STAFF REPORT

SUBJECT: H-2020-0124
Ambles Run Subdivision

Annexation & Zoning of 2.88 acres of land with an R-2 zoning district and a preliminary plat consisting of 6 single-family residential lots, by HomeFound Group.

B. Preliminary Plat (dated: 12/17/2020) **NOT APPROVED**

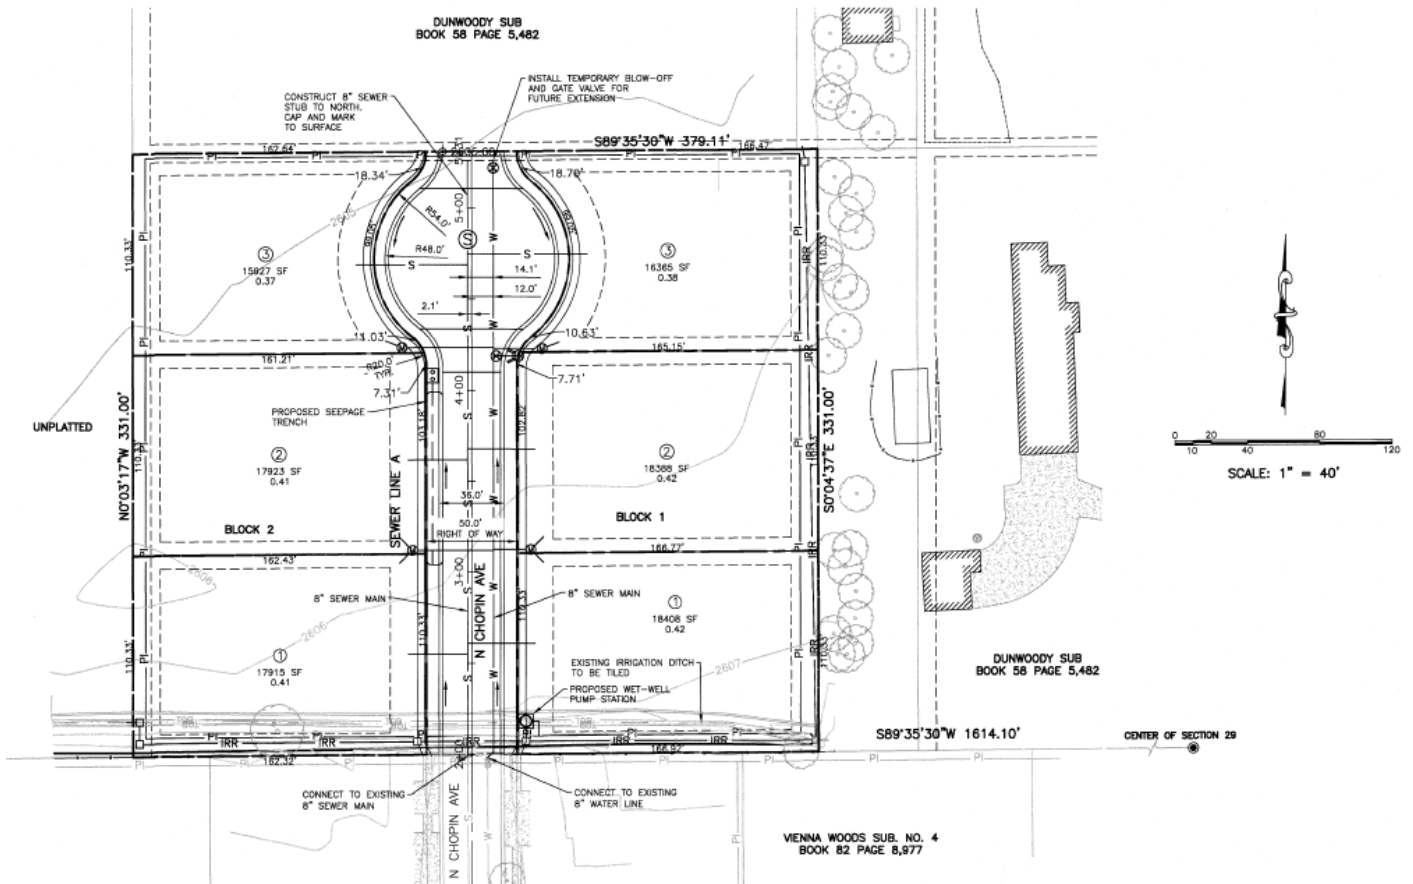
The proposed layout is sufficient for the proposed 6-lot subdivision but Staff believes it does not adequately set the stage for future development to its north and west. Therefore, Staff is recommending the Applicant revise the plans to show a stub street to the west as discussed to meet more of the comprehensive plan objectives and policies. There are multiple placements of the stub street that would provide for better future circulation than only providing a stub to the north. However, Staff finds it appropriate to recommend a location that minimizes the amount of wasted pavement should Chopin Avenue ever get extended further in the future.

As discussed previously, the proposed 4-foot wide sidewalks do not meet ACHD standards and should be widened to 5 feet wide. The Applicant is aware of this but has not yet provided updated plans. Regardless, the sidewalks in this development will continue connections through the project from the Vienna Woods Subdivision to the south. These connections will allow future residents easy access to the nearby sports complex to the southeast.

- a. ~~Revise the plat to show an additional stub street from Chopin Avenue to the western boundary along the northern property line coordinate with ACHD on the width of the stub street section right of way.~~

- b. Revise the plat to show 10-foot wide parkways with 5-foot wide detached sidewalks consistent with UDC 11-3A-17 and Staff's recommended changes.
3. The landscape plan included in Section VII.D, dated November 18, 2020, shall be revised as follows ~~at least ten (10) days prior to the City Council hearing with the final plat submittal:~~

C. Landscape Plans (date: 12/18/2020) NOT APPROVED

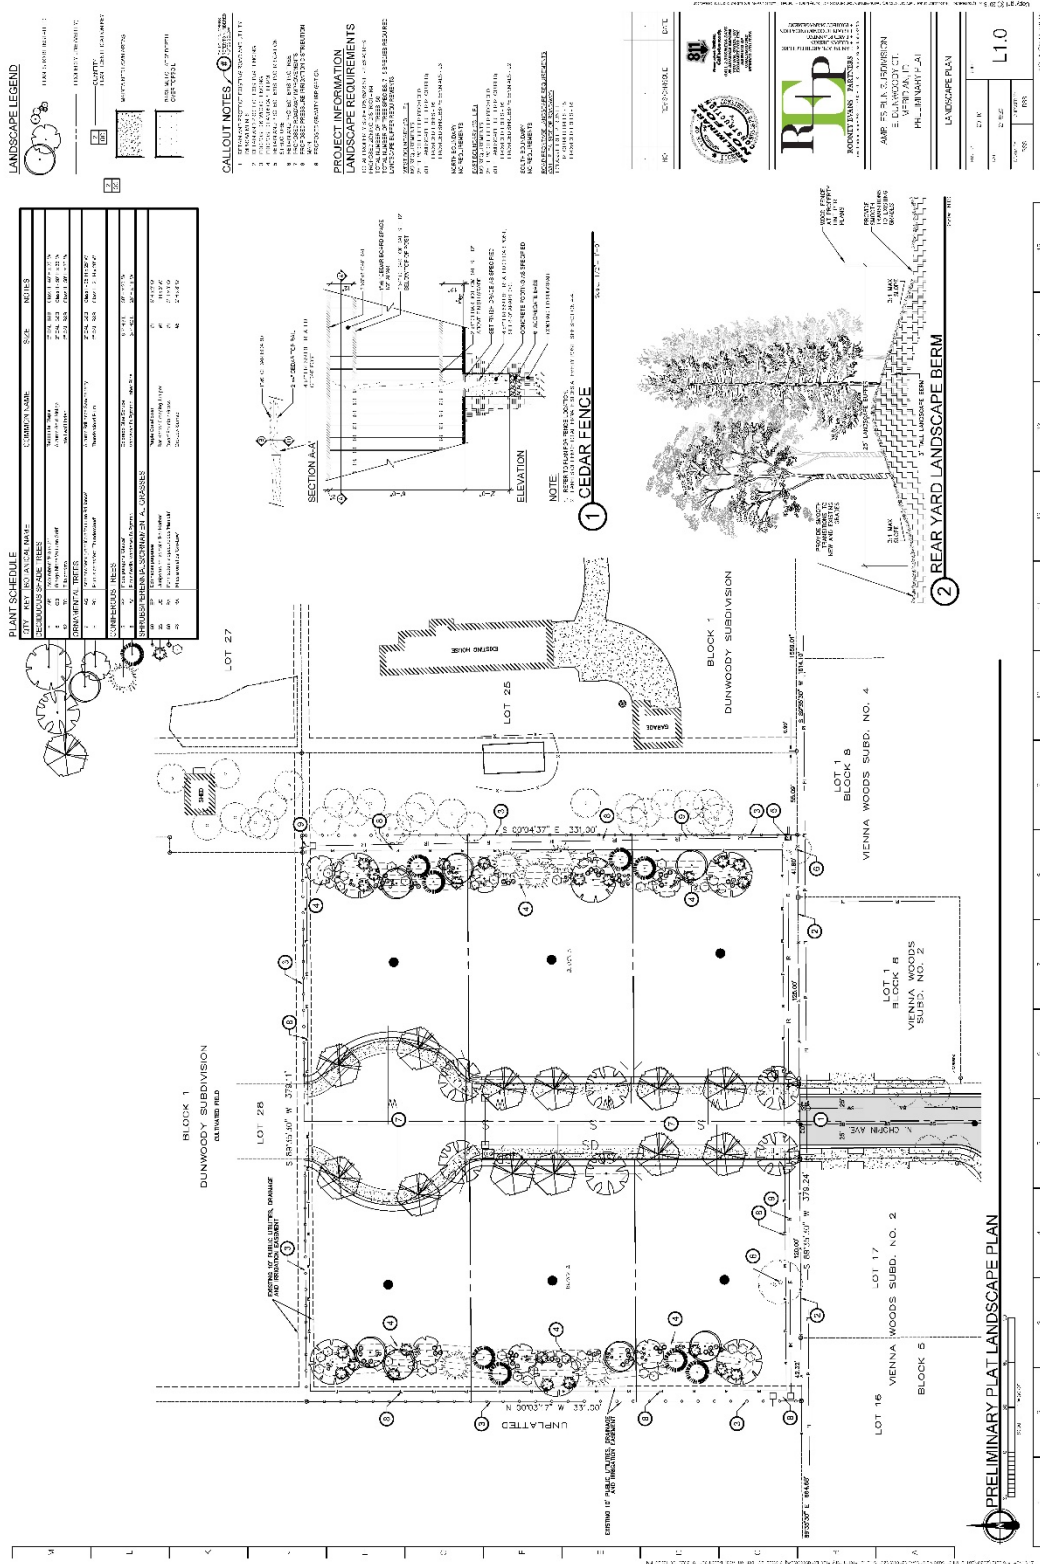
Staff is recommending the proposed parkways be widened to 10' to increase the amount of open space for the small development even though there is not a requirement to meet any minimum open space standard. As discussed within the Comprehensive Plan analysis section earlier, increasing the width of the parkways allows the project to provide at least 5% open space which helps meet the intent of the code and comply with the comprehensive plan. In addition, the wider parkway would allow for healthier trees and provide the Applicant the opportunity to use a wider range of trees within the parkways, including larger Class III trees if so desired. Staff recommends constructing the recommended western stub street with 8-foot parkway on its southern side to match what is currently proposed. This parkway should also be landscaped in accord with UDC standards.

- a. ~~Revise the plan to show the revised plat layout per conditions above.~~
 - b. Revise the plan to show 10-foot wide parkways.
4. Future development shall be consistent with the minimum dimensional standards listed in UDC Table 11-2A-4 for the R-2 zoning district.
